Docket 50-57

License R-77

In support of our application for renewal of our operating license R-77, I have enclosed a partial response to your questions dated January 21, 1983. Questions 5 and 10 require additional effort, and I anticipate submittal of answers to these two questions within two weeks.

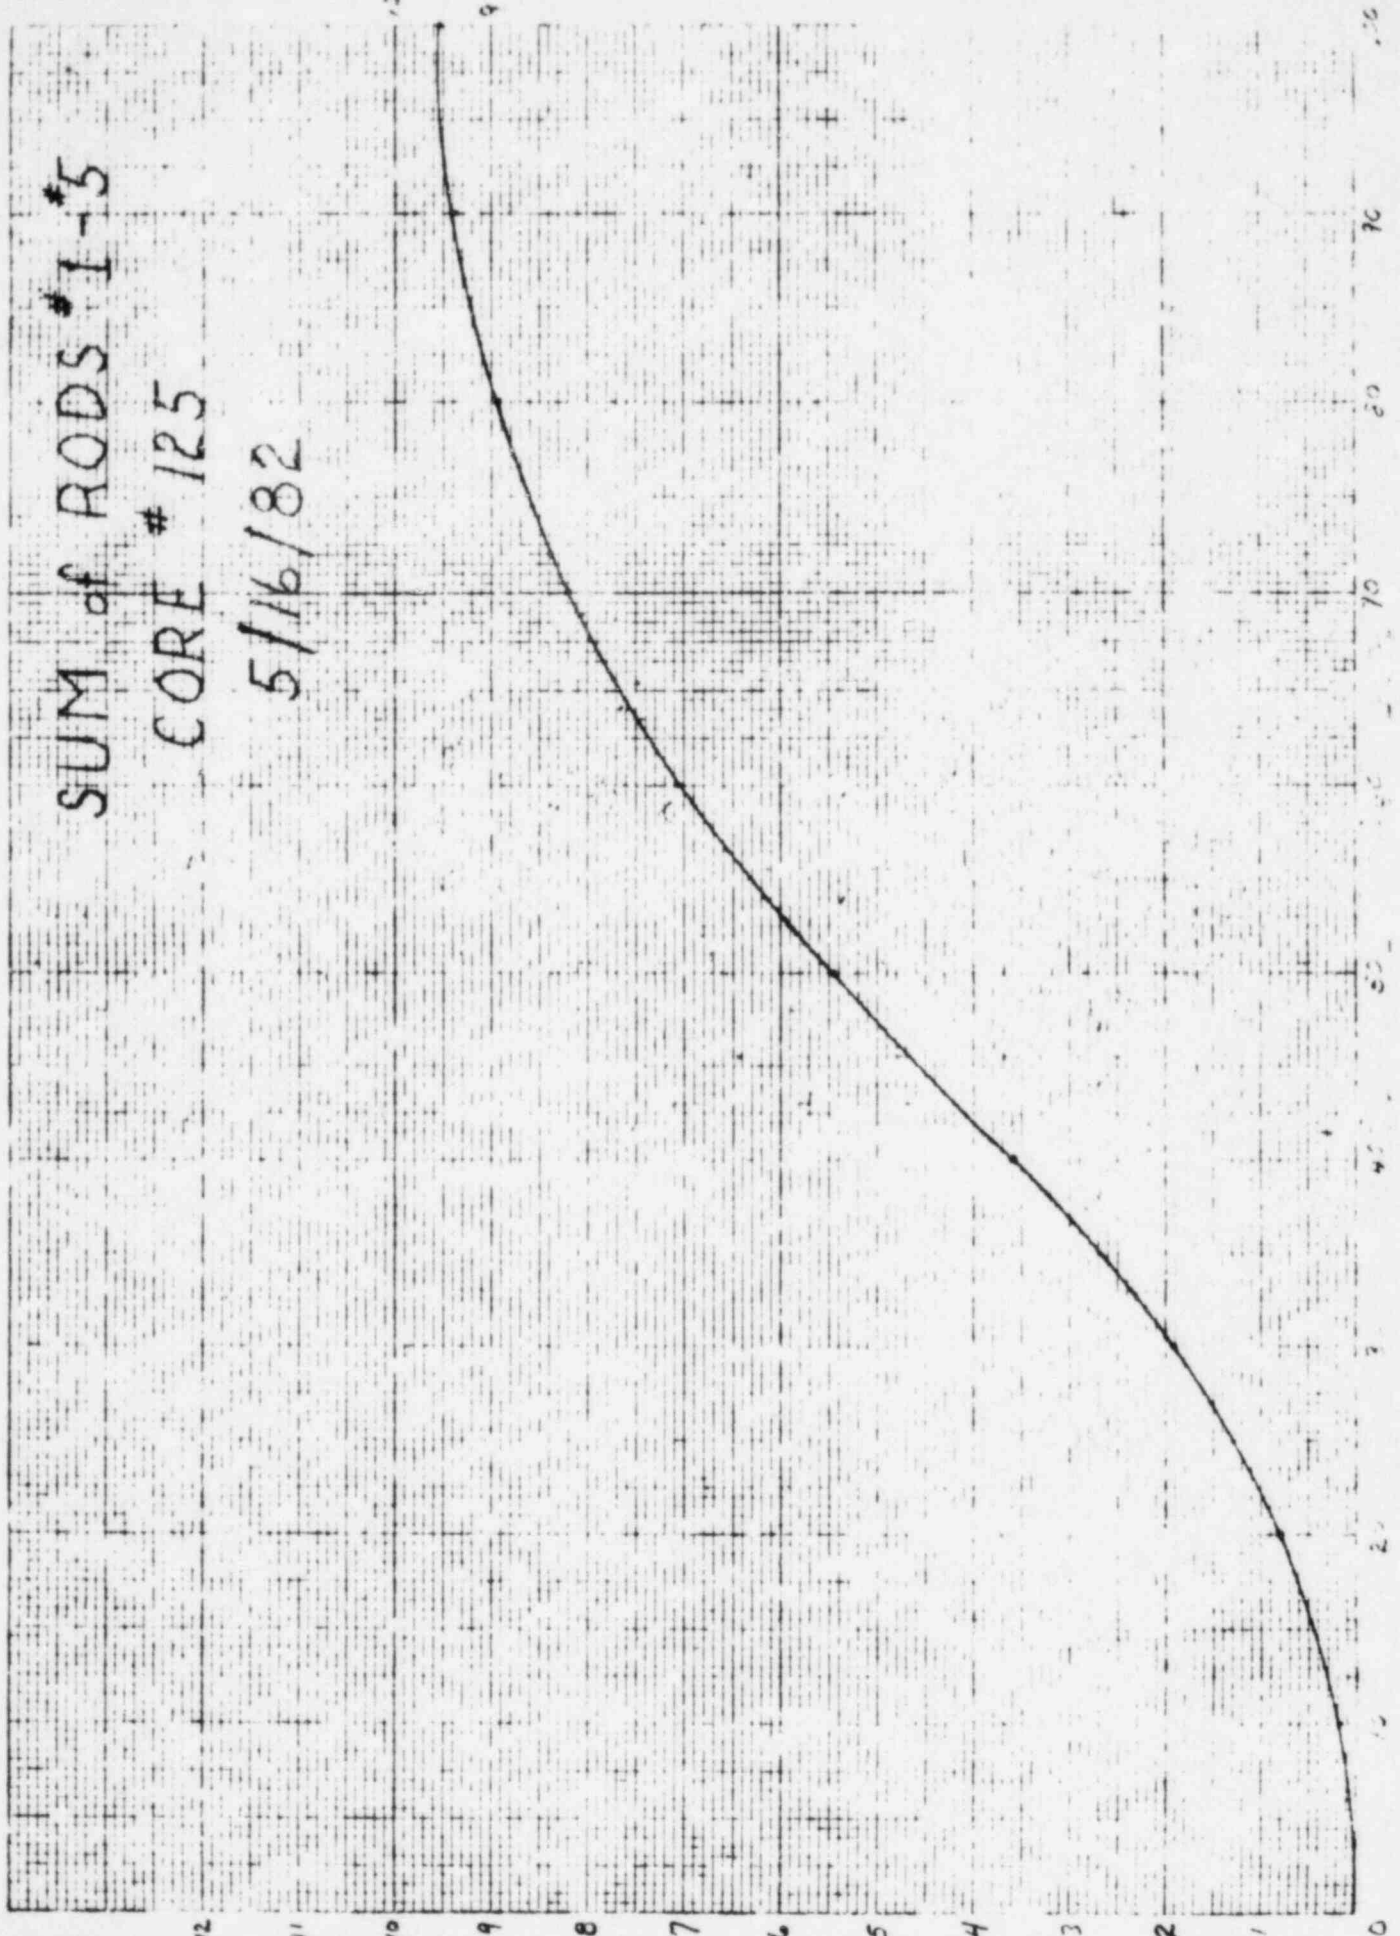
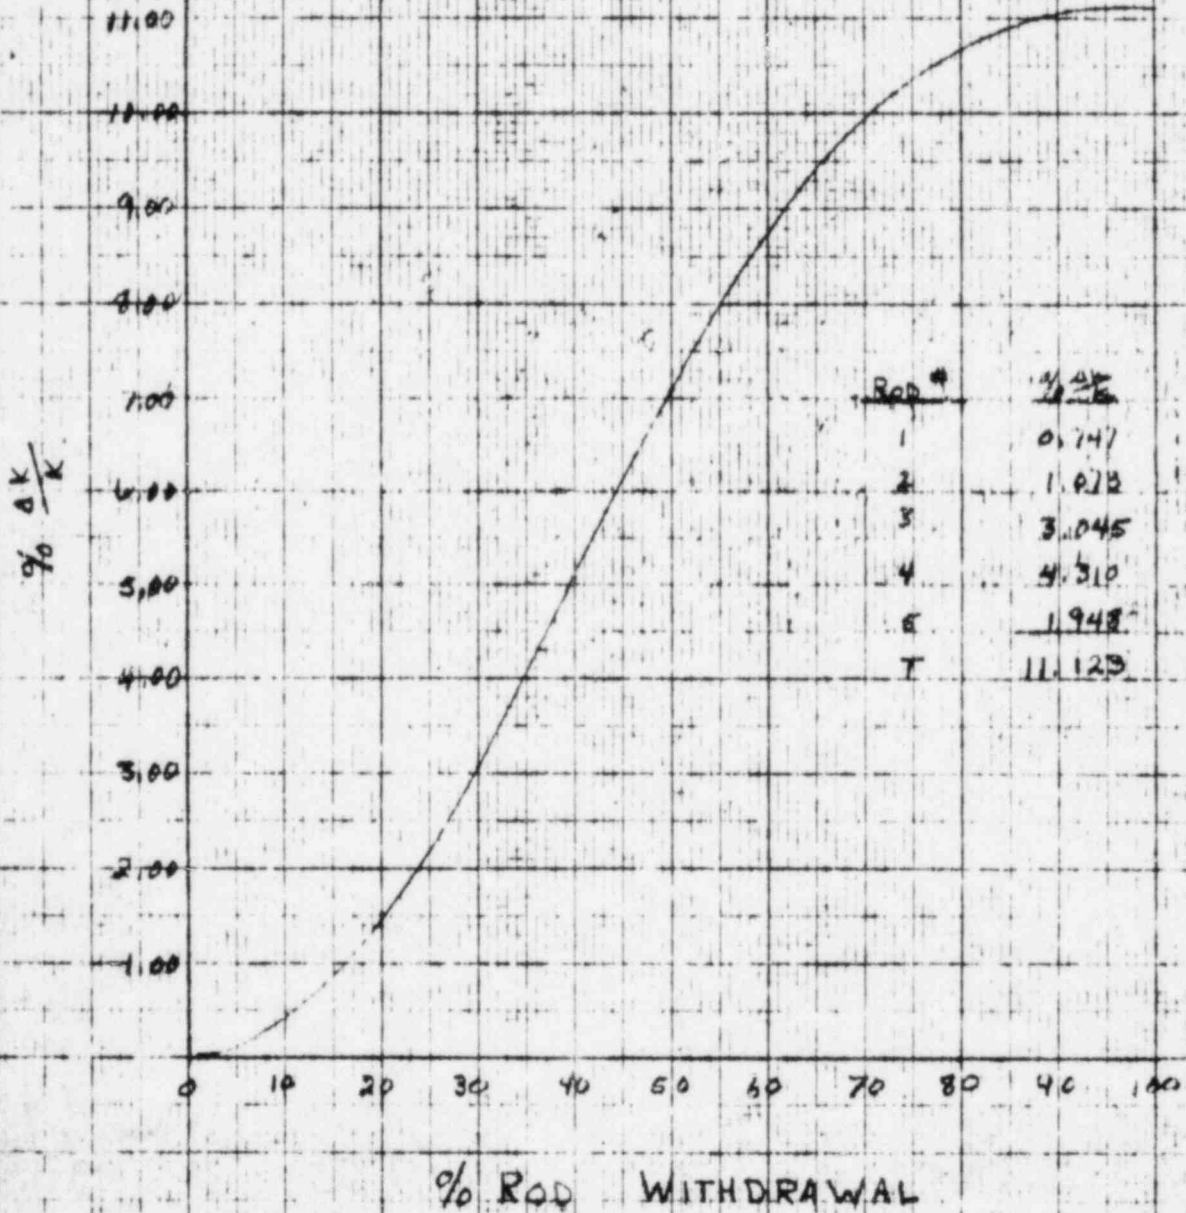
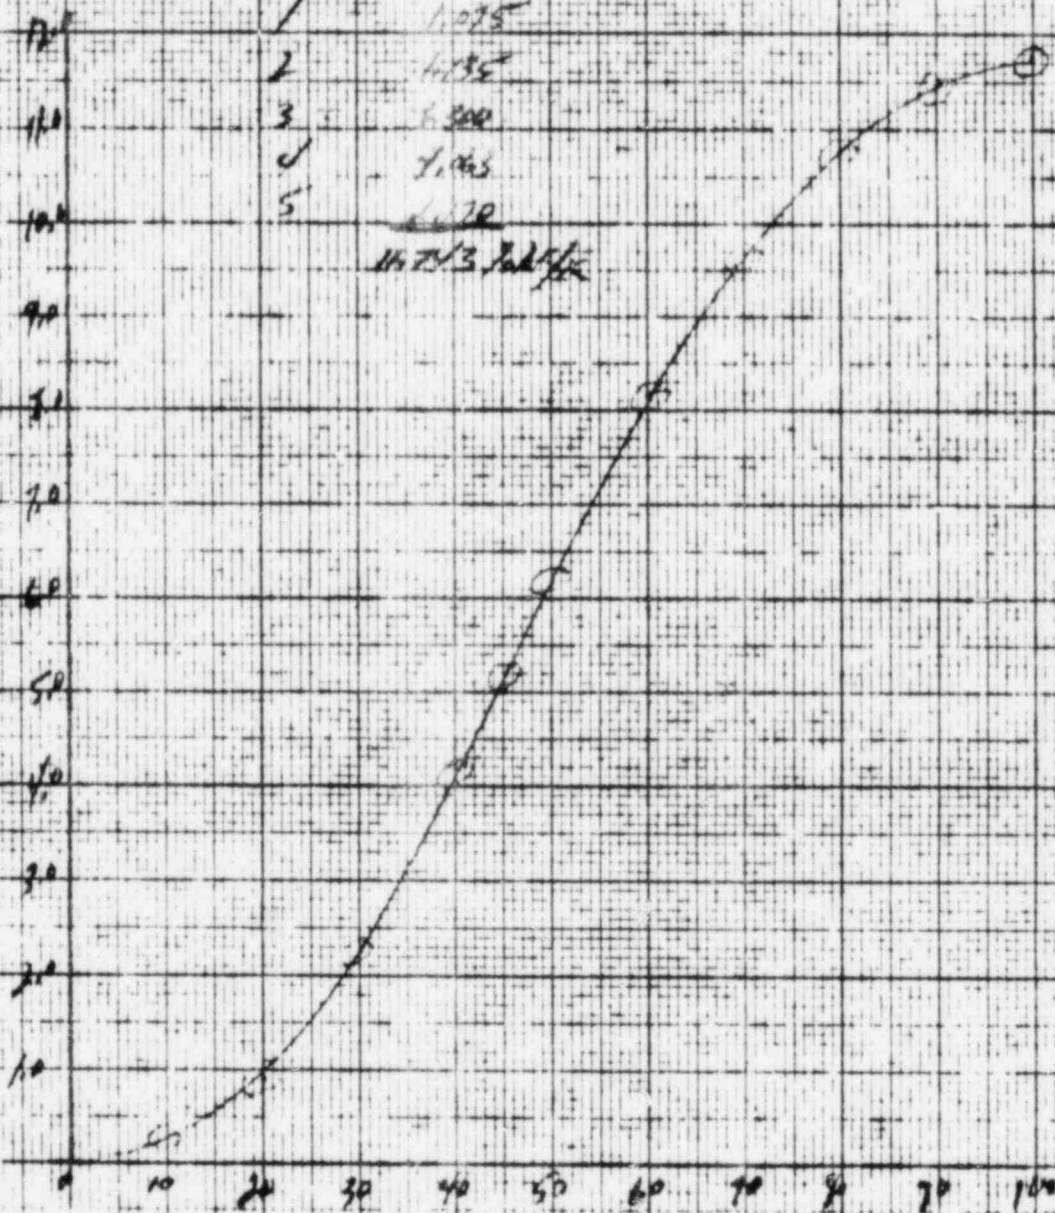
4. Diagrams and curves are provided as requested.
6. It is our intention to install an electro-mechanical flow velocity sensor in the stack exhaust line. The electronic signal will be transmitted to an audible and visual alarm in the reactor control room. We anticipate installation within sixty days.

Figure 1

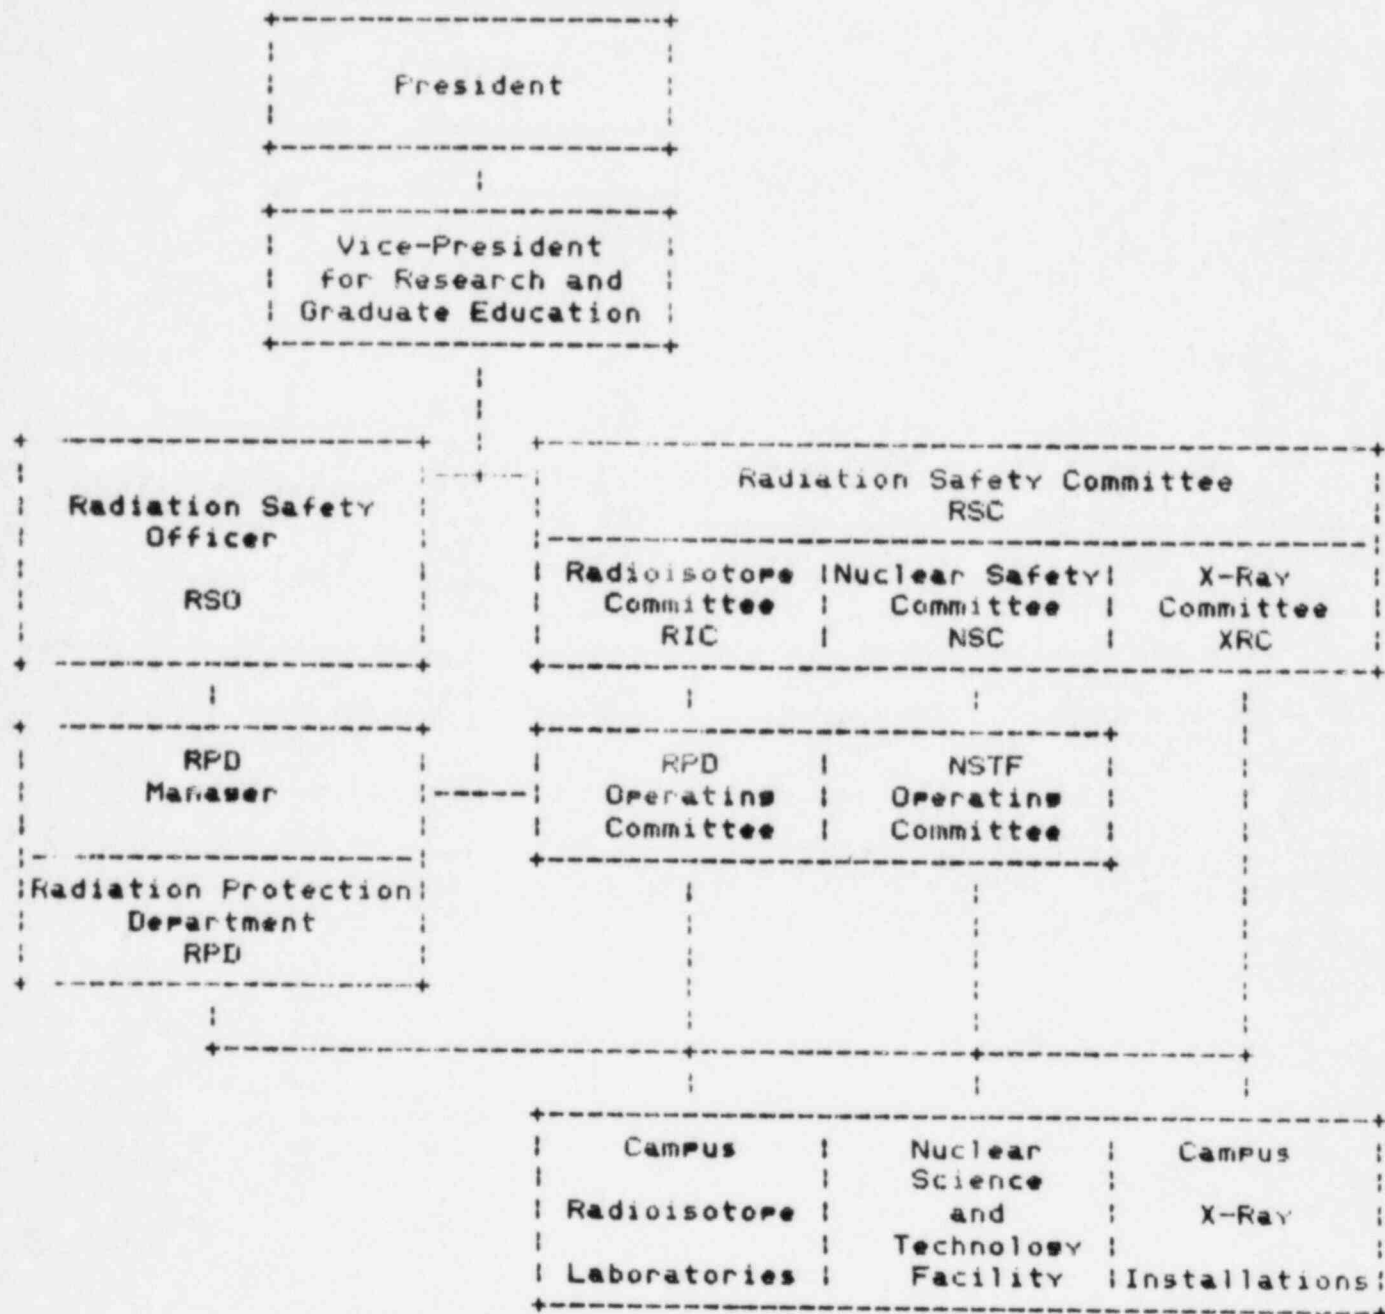
18. The Radiation Protection Department (RPD) organizational chart is shown in Figure 1. The Radiation Safety Officer (RSO) establishes policy in consultation with the Radiation Safety Committee (RSC) and implements procedures through the operations of the RPD. (A copy of the RSC Constitution and By-Laws are attached.) The RSO has the authority to immediately discontinue any operation deemed to constitute an undue radiological hazard. The RPD Manager has the responsibility to ensure that the radiation protection program is properly implemented on a day-by-day basis. The RPD Manager reports to the Campus Radiation Safety Officer.

The technical staff (in-house titles "Senior Radiation Safety Monitor" and "Radiation Safety Monitor") are responsible for the day-to-day operations of the RPD. These would include surveys of areas in which radioactive material or radiation-producing equipment are used, enforcing radiation protection regulations, maintaining required records, performing instrument calibrations and quality control of instruments, training of workers in radiation protection, etc. Technical staff have the authority to issue written citations to users who violate regulations. One staff member is assigned exclusively to the NSTF, while three staff members are assigned to the Campus. Technical staff report to the RPD Manager.
